That he is a Vice President of Florida Power & Light Company,
the Licensee herein;

HOT CHANNEL FACTOR
NORMALIZED OPERATING ENVELOPE
(for steam generator tube plugging 22% and $F_q=1.99$)

HOT CHANNEL FACTOR-NORMALIZED
OPERATING ENVELOPE (FOR STEAM
GENERATOR TUBE PLUGGING $\leq 25\%$ and $F_q = *$)

Figure 3.2-3a

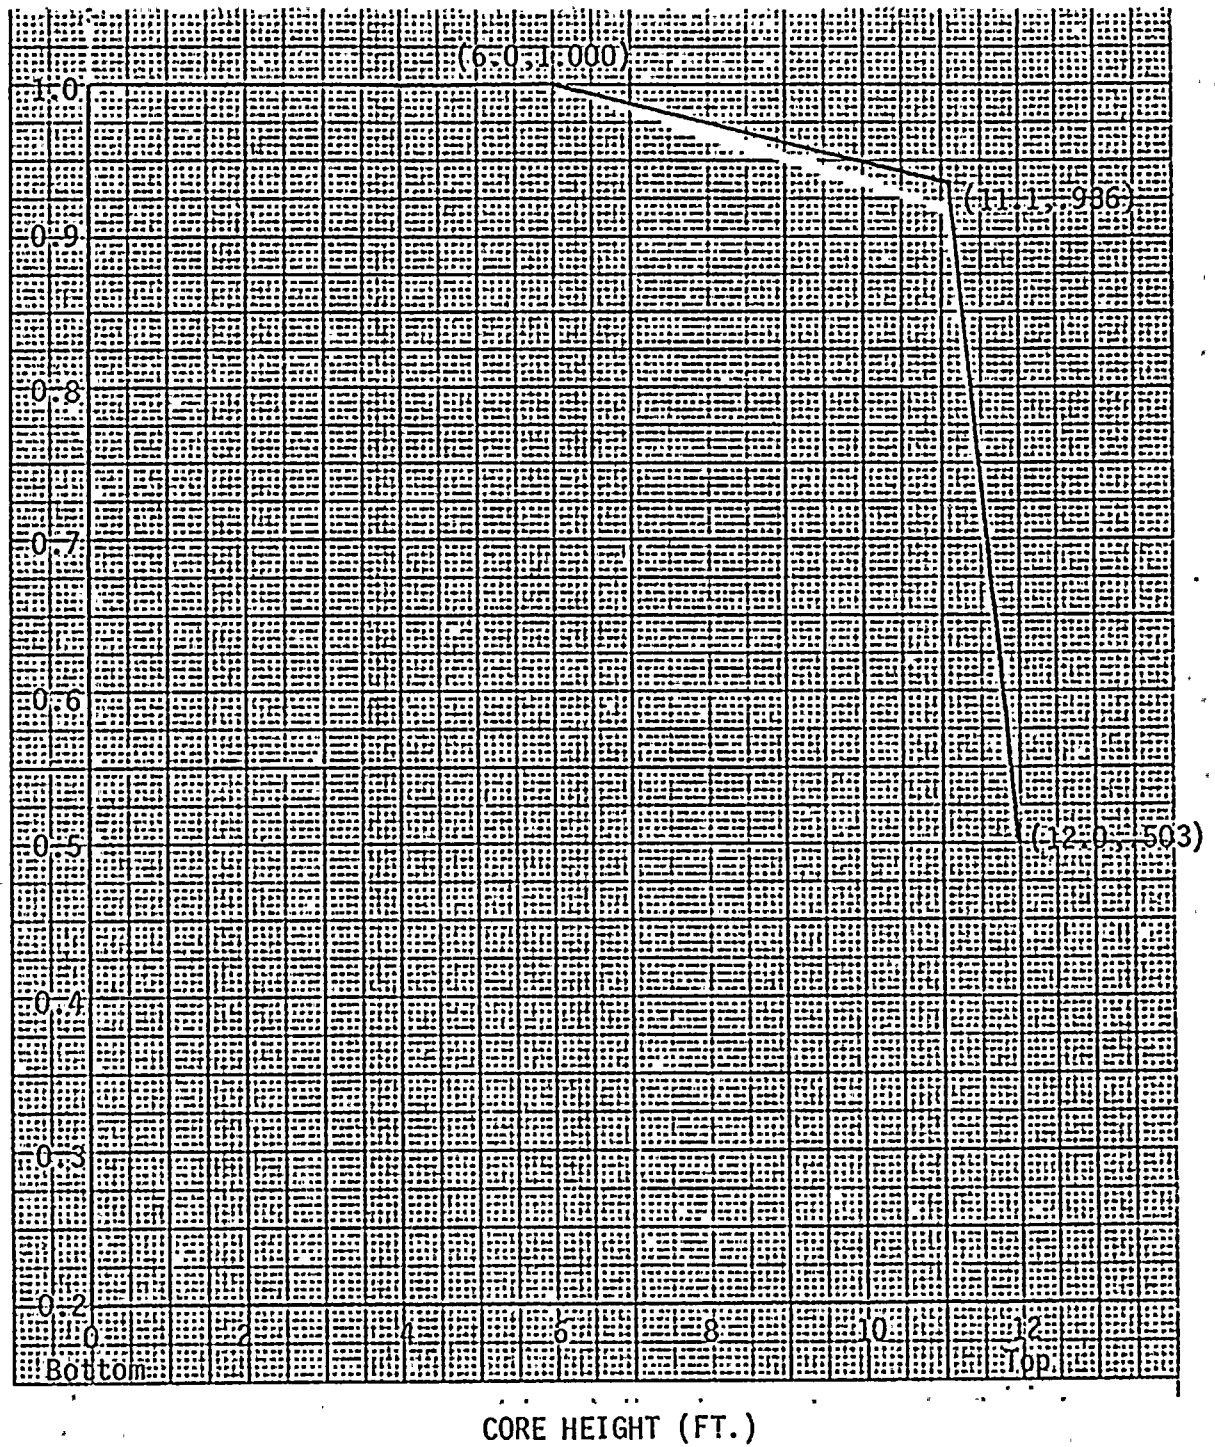
- (2) With steam generator tube plugging $\leq 22\%$, the hot channel factors (defined in the basis) must meet the following limits at all times except during low power physics tests:

Where P is the fraction of rated power at which the core is operating; K(Z) is the function given in Figure 3.2-3a; Z is the core height location of F_q .

FIGURE 3.2-3b

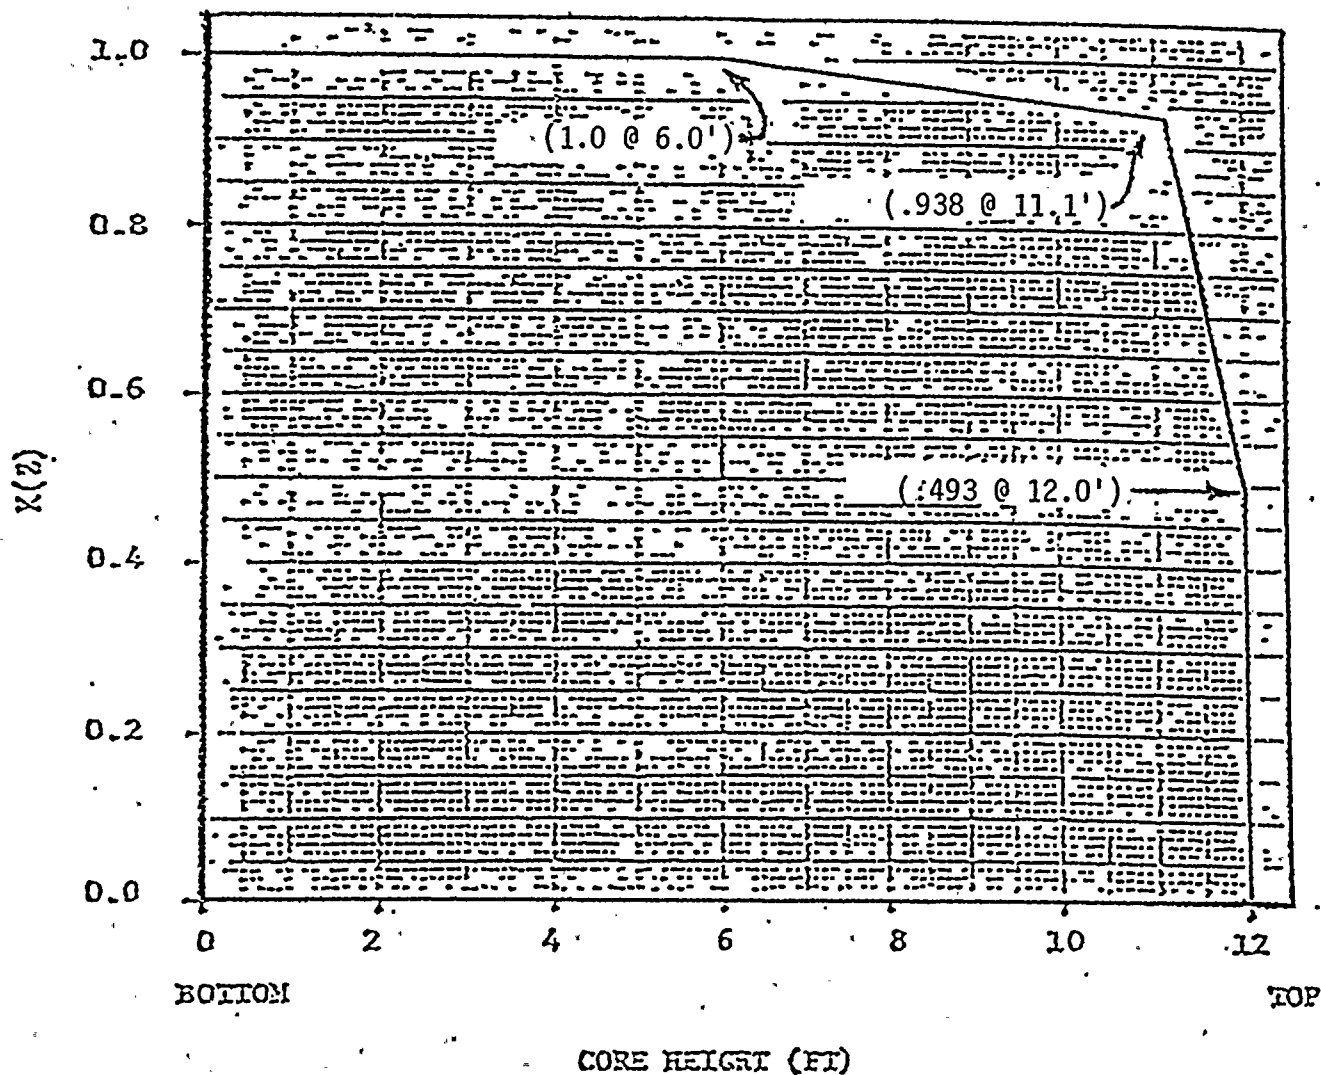
- (1) With steam generator tube plugging $>22\%$ and $\leq 25\%$, the hot channel factors (defined in the basis) must meet the following limits at all times except during low power physics tests:

Where P is the fraction of rated power at which the core is operating; K(Z) is the function given in Figure 3.2-3b; Z is the core height location of F_q .

If F_q , as predicted by approved physics calculations, exceeds (*), the power will be limited to the rated power multiplied by the ratio of (*) divided by the predicted F_q , or augmented surveillance of hot channel factors shall be implemented.

* To be supplied based on results of revised ECCS analysis for 25% steam generator tube plugging.
